Draft Grid Code Modification Report		At what stage is this document in the process?												
<h1 style="color: #008080;">GC0114:</h1> <h2 style="color: #008080;">Mod Title: ‘System Operation Guidelines Prequalification Processes’</h2>

This document is the Draft Final Grid Code Modification Report document that contains the discussion of the Workgroup which formed in June 2018 to develop and assess the proposal, the responses to the Workgroup Consultation which closed on 27 September 2018, the voting of the Workgroup held 05 December 2018. The Panel reviewed the Workgroup Report at their Grid Code Review Panel meeting on 19 December 2018 and agreed that the Workgroup had met its Terms of Reference and that the Workgroup could be discharged. This document also contains the responses received from the Code Administrator Consultation which closed on 28 January 2019.

GC0114 aims to clarify that the EU System Operation Guideline (SOGL) requires NGESO to develop prequalification processes for Frequency Containment (FCR), Restoration (FRR) and Replacement Reserves (RR). In line with stakeholder feedback NGESO proposes to develop these new processes under the established governance of

Figure 5 – Static FFR ramp test requirements (copy FFR Guide Figure 2.1)

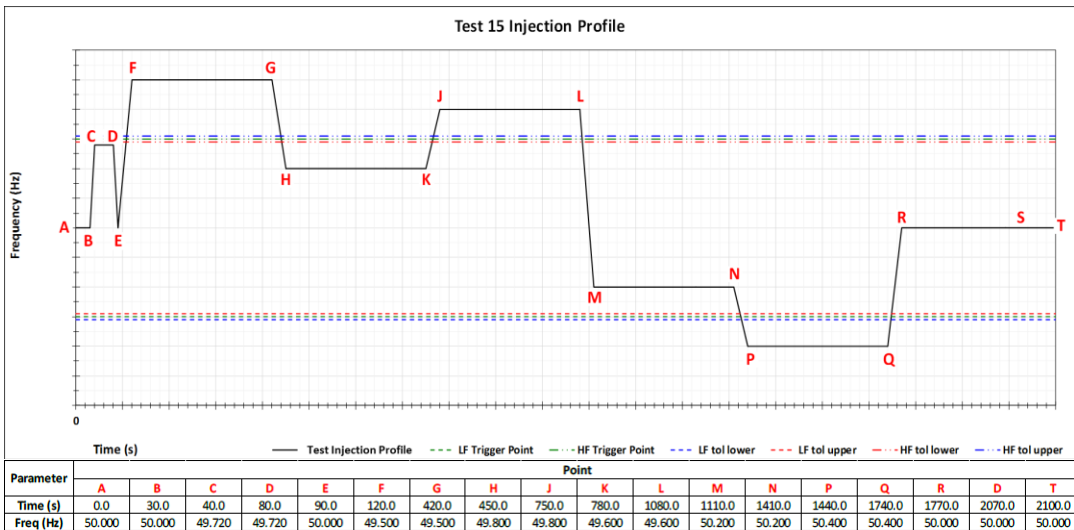
FFR Static service tests require a series of 30 second ramp tests an example of which is shown in figure 5. It would seem logical that the duration tests which are in the dynamic section would be included for the Static service but they do not seem to be.

Figure 9 – Grid Code Primary, Secondary & High test requirements (copy Figure ECC.A.3.3 & ECC.A.3.4)

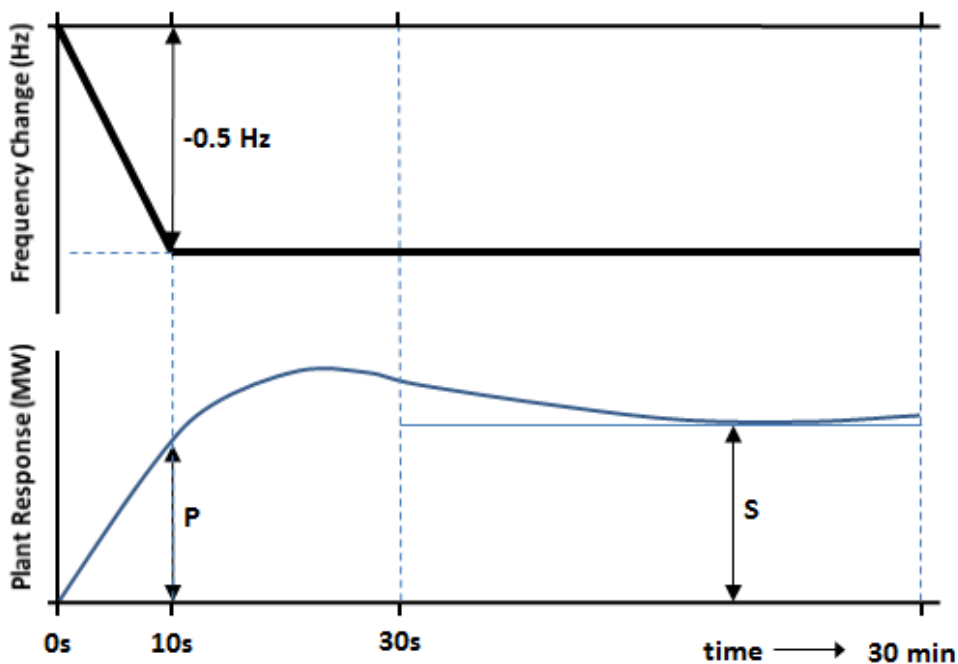
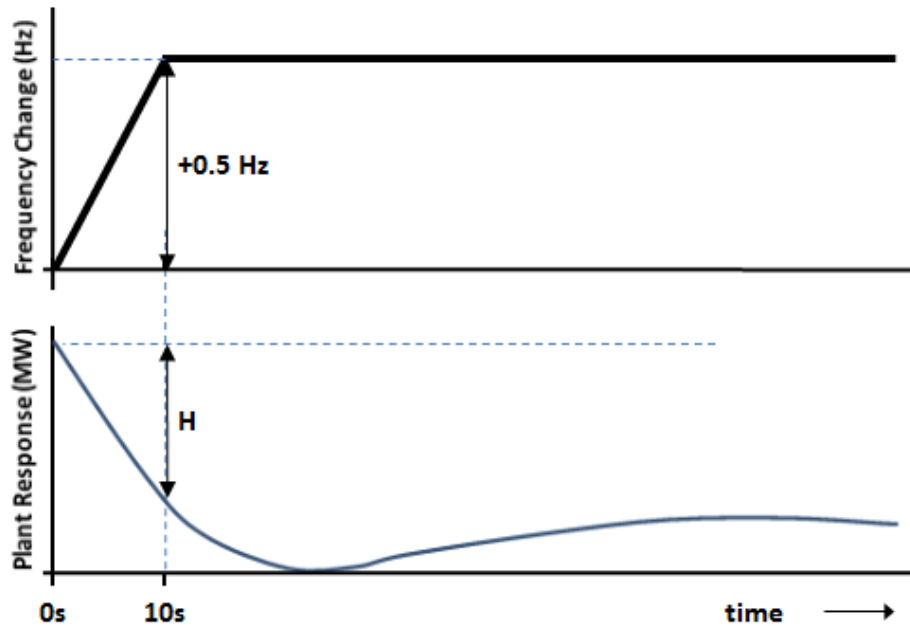
Given that all tender returns require primary, secondary and high response values it is surprising that only the MSA tests require these tests, with both the guidance documents for FFR and EFR using step tests and ramps of longer durations.

Figure 10 – Comparison of responses to a -0.5Hz step and ramp test

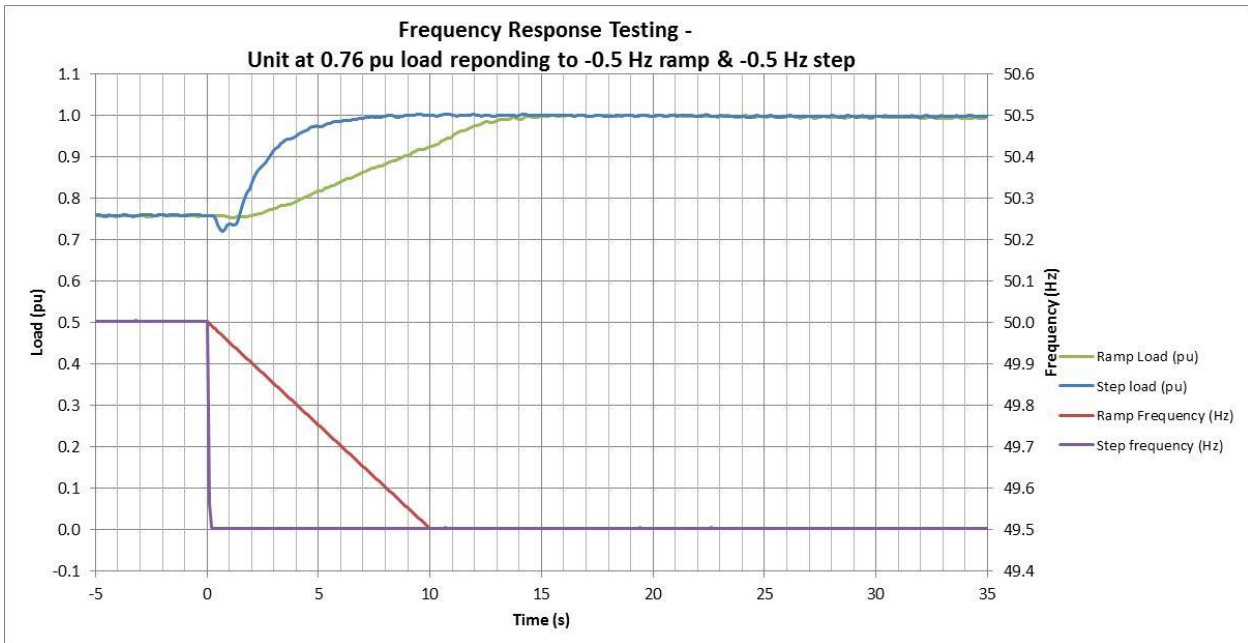
Reviewing the primary response in figure 10 based on a 10s ramp the response is 0.186 pu, whilst if the result is based on a step test the response is 0.241pu, hence a ramp test only gives 70% the response of a step response. Similarly the high response in figure 11 based on a 10s ramp the response is 0.191pu, whilst if the result is based on a step test the
